RE: **Perc Cert Comment, Tax Map 28, Parcel 13, Parcel 'A'; A534508**

RE: **Perc Cert Comment, Tax Map 28, Parcel 13, Parcel 'A'; A534508**

RE: **Legend issues on Perc Cert. The Oaks at Bridle Creek Parcel 'A' Tenant House and Clubhouse; A534508**

| DRAWN EDS | THE OAKS AT BRIDLE CREEK AGRICULTURAL LAND PRESERVATION # HO-91-15-E Parcel 'A' - Clubhouse | DRAWING 3 OF 3 |

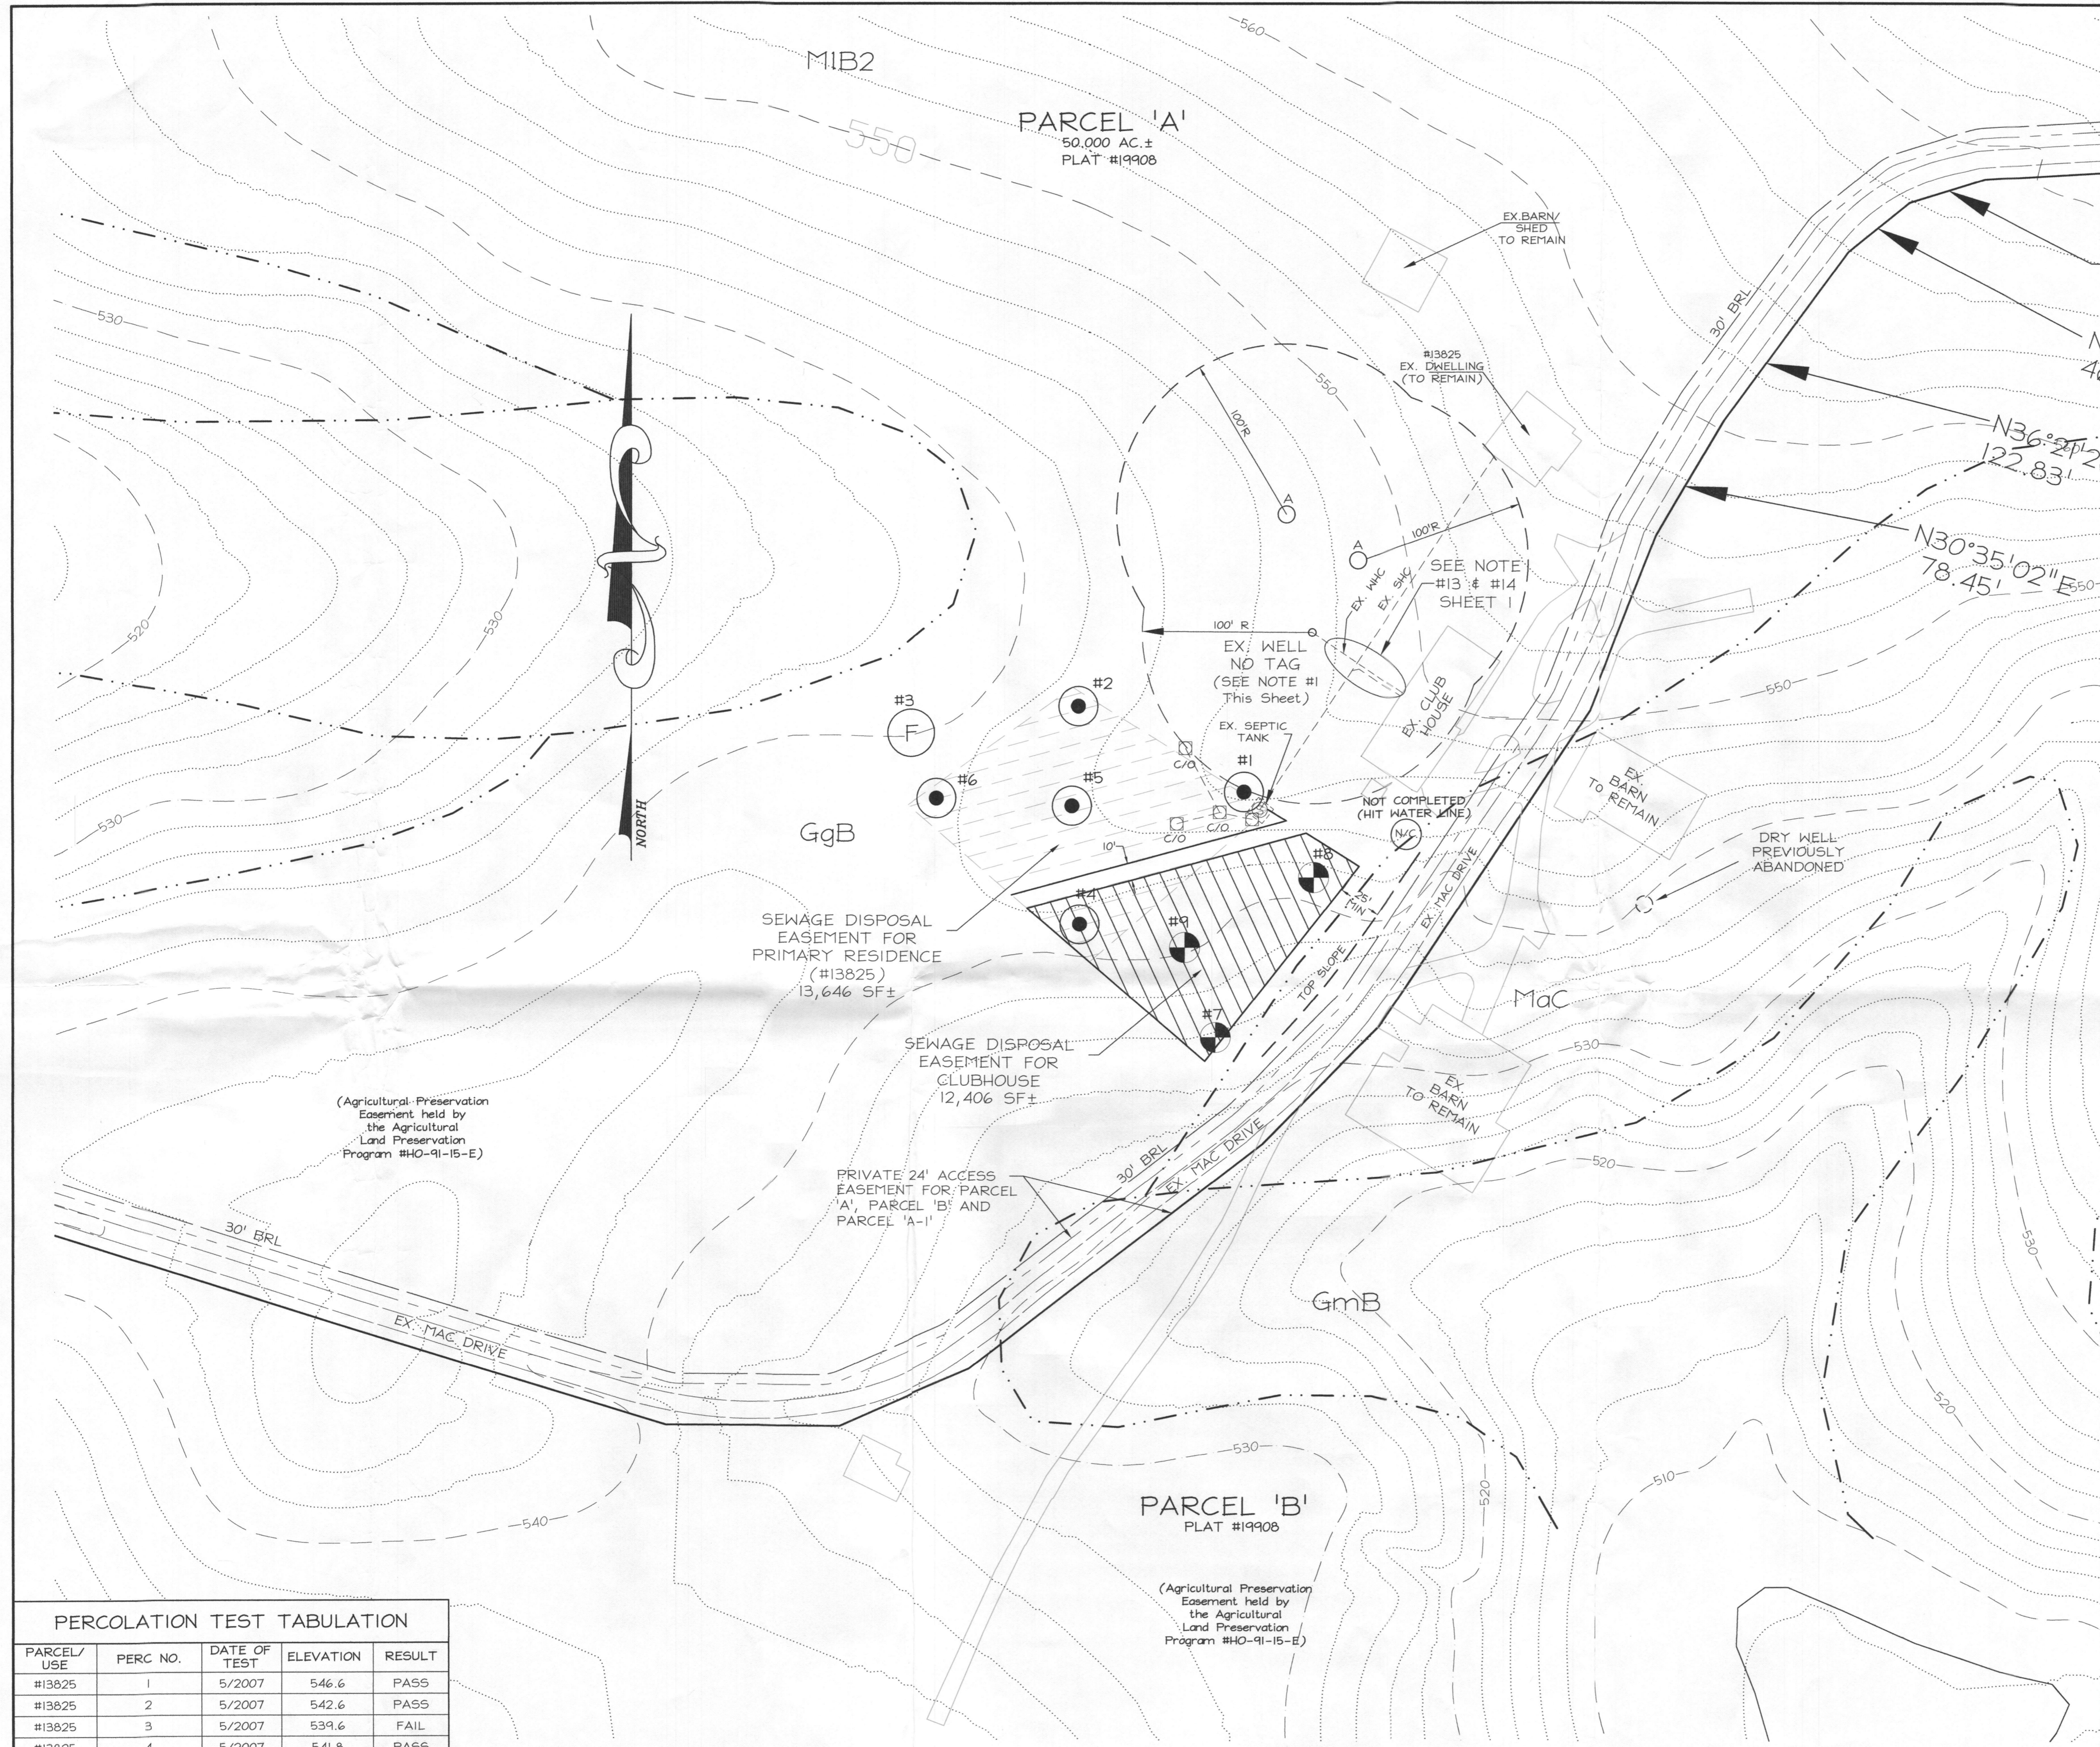
1. On Sheet 1 the existing septic reserve had not been shown with the area to be added for the clubhouse use.
2. On Sheet 1 add a note astating that use of the well is shared among the primary residence and the clubhouse.
3. On Sheet 3 (and on Sheet 1) show a 'buffer' 5 ft- to- 10 ft width, between the septic reserve areas for the primary residence and the clubhouse.

- i. Change initials in symbol from "W T" to 'F'
 - ii. Change entry to Percolation Test Location
 - iii. Add the term "-FAIL".
 - c. Add the term "-PASS" to 'Percolation Test Location (4/27/11)' entry.
 - d. Add an entry for "Percolation Test Location Not Completed", and utilize a symbol different than the other three perc test entries.
 - i. Apply this symbol to location labeled "Not Dug"
 - ii. Change the label to NOT COMPLETED (HIT WATER LINE)
 - e. Delete the entry for well box as these were approved as discrete proposed alternate well locations and existing well location.
 - f. Delete the entry for "proposed primary well".
8. Sheet 3, plan: Delete "ex well box" label and symbol (re: lines, triangle).

15. 'Existing sewage disposal area': the symbol in the legend is oriented in a different direction than the symbol on the plan in the existing area shown on the plan.
16. 'Soil Divide': re-title as "Soil Survey Delineation".
17. 'Existing 10' contour', correct the number in the Legend symbol.
18. 'Existing 2' contour', delete the number in the Legend symbol.
19. 'Existing well': maintain consistency with the symbols on SHEET 1.
20. 'Building Restriction Line': correct the symbol in the Legend to more closely match the symbol on the plan and label the delineation on the plan as 'BRL'.
21. SHEET 3 plan: eliminate (re: delete) the term 'existing' from label for dry well, leaving "dry well previously abandoned".

| DRAWN | THE OAKS AT BRIDLE CREEK AGRICULTURAL LAND PRESERVATION # HO-91-15-E Parcel 'A' - Tenant House | DRAWING | 2 OF 3 |

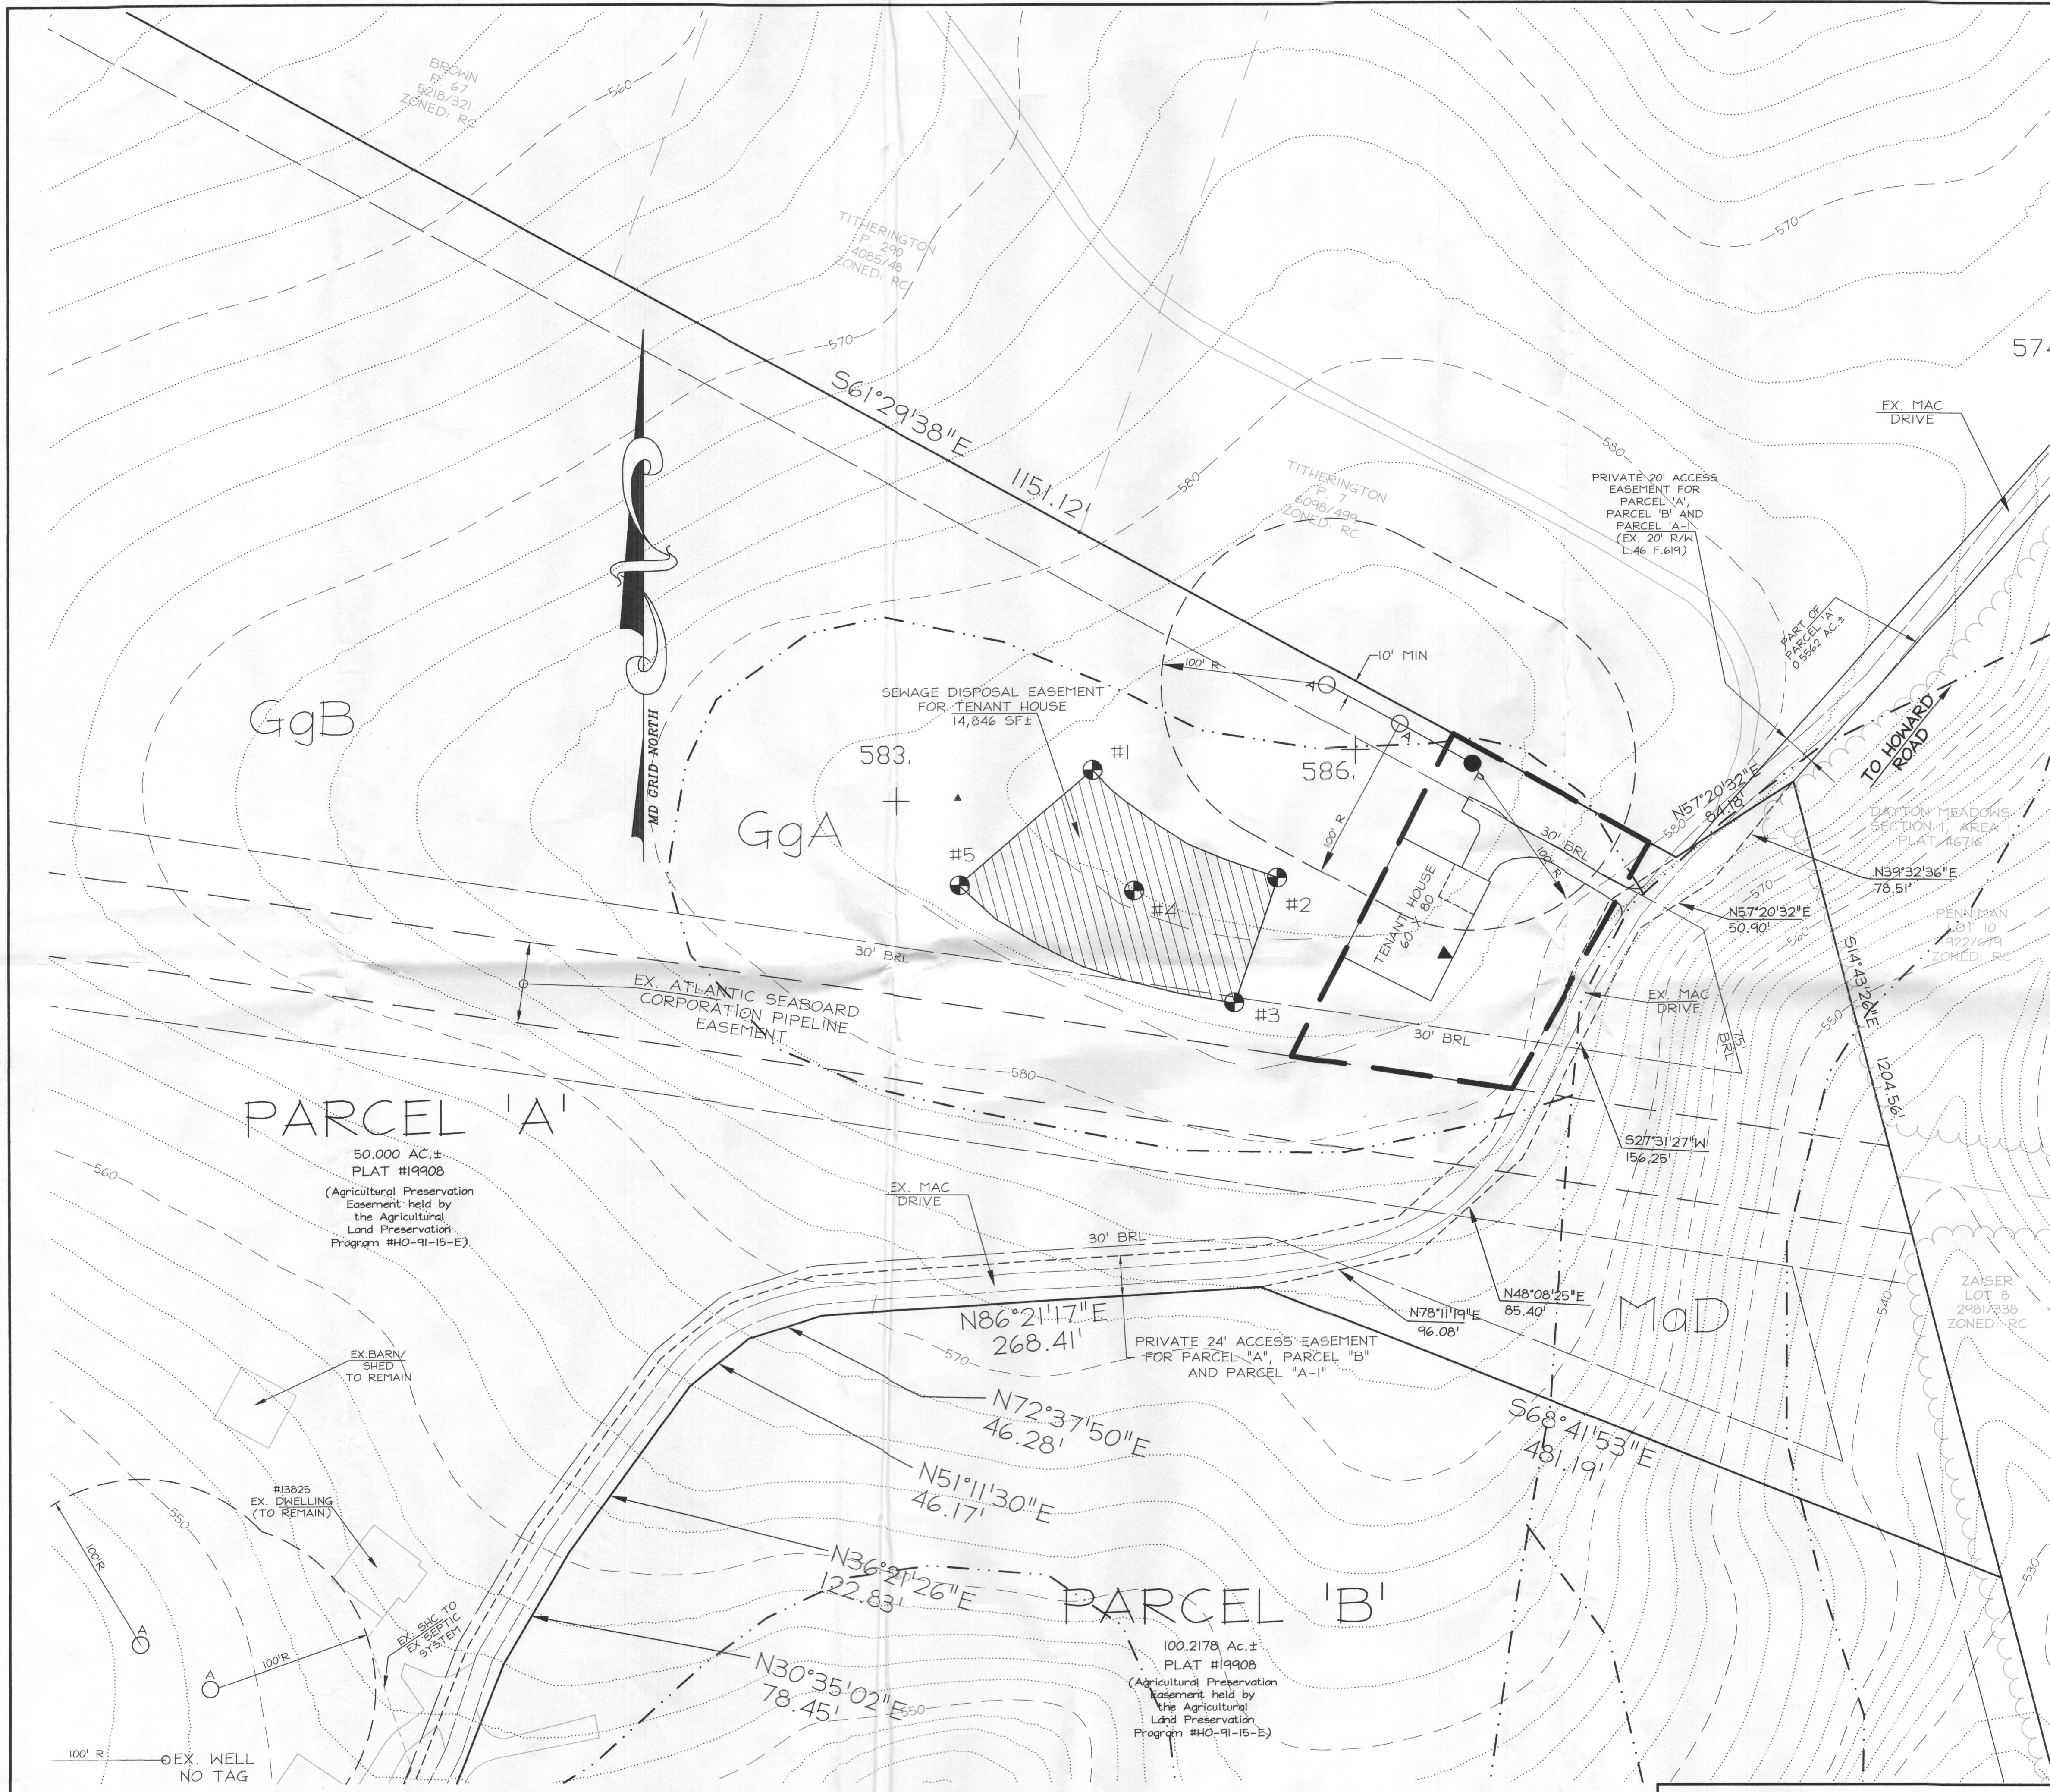
5. Sheet 2, LEGEND:
 - a. Add the term "-PASS" to 'percolation test location' entry.
 - b. Delete entry for 'well box'.
 - c. Delete entry for "existing well".

- d. Correct the symbol for "proposed tenant house".
 - e. Correct the symbol for "proposed primary well".
6. Sheet 2, plan: Delete "well box" label.
7. Sheet 3, LEGEND:

9. 'Proposed Sewage Disposal easement': two different symbols are used on the plan, and both differ from the example in the legend as the symbols in the proposed areas on the plan are oriented in a different direction.
10. 'Existing sewage disposal area': DELETE, none shown.

11. 'Soil Divide': re-title as "Soil Survey Delineation".
12. 'Existing 10' contour', correct the number in the Legend symbol.
13. 'Existing 2' contour', delete the number in the Legend symbol.
14. 'Building Restriction Line': correct the symbol in the Legend to more closely match the symbol on the plan.
